APPLICATION NO: 02/2019/0183/ PR

PROPOSAL: Details of appearance, landscaping, layout and scale of 2 no. dwellings submitted in accordance with condition no. 1 of outline planning permission code no. 02/2018/0445

LOCATION: Land to rear of Ty Cefn Llanfwrog Ruthin

SITE ELEVATION/SECTION DETAIL
1:200

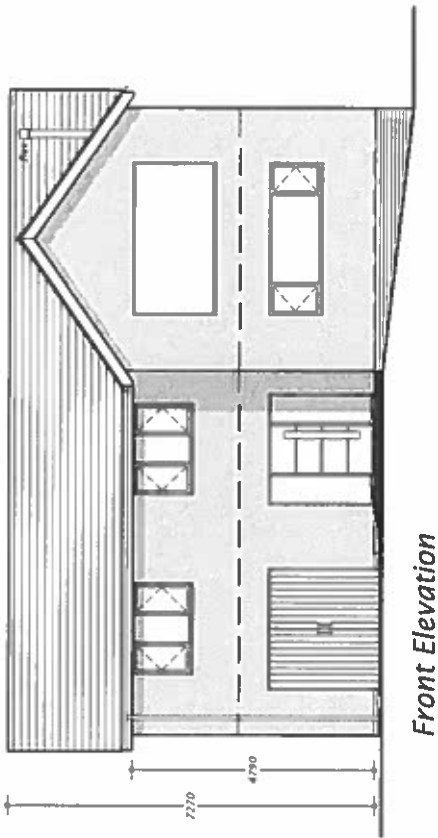
“Object for the following reasons: The proposed dwellings remain too large for the site in terms of size and massing. The dwellings would be close together and close to the site boundaries.”

Concerns have been raised locally and by the Town Council in respect of the scale and mass of the dwellings.

From observation, dwellings in the locality and the immediate vicinity of the site are of varying size and detailing. Respectfully, Officers would not consider they are too large either in relation to the dwellings surrounding them, the locality, or in relation to plot sizes. Officers consider the proposals show an acceptable scale of development in keeping with the area.

PLOT 2 DWELLING

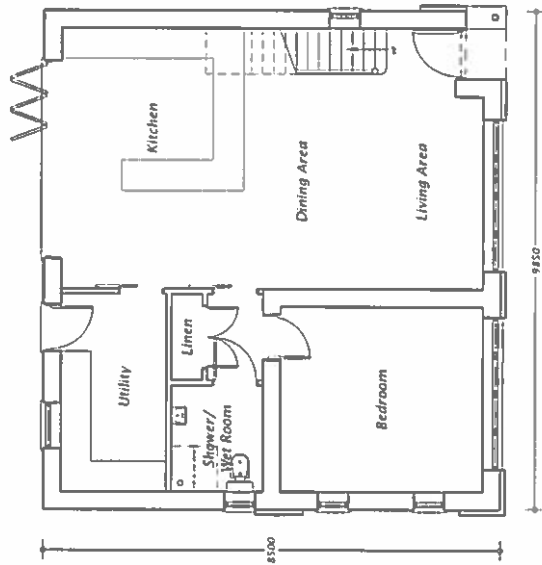
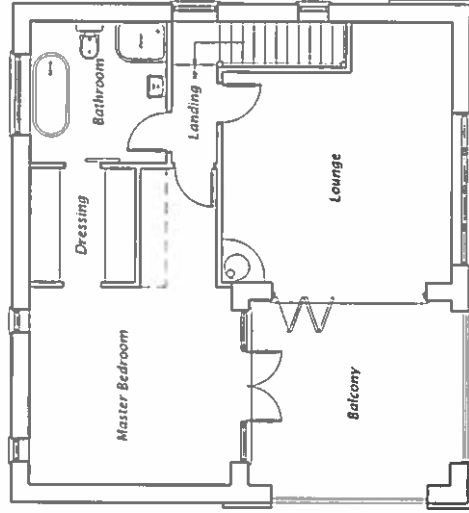
- 1.5.1 Since the original submission, the size of the dwelling on plot 2 has been reduced through the omission of a single storey integral side garage
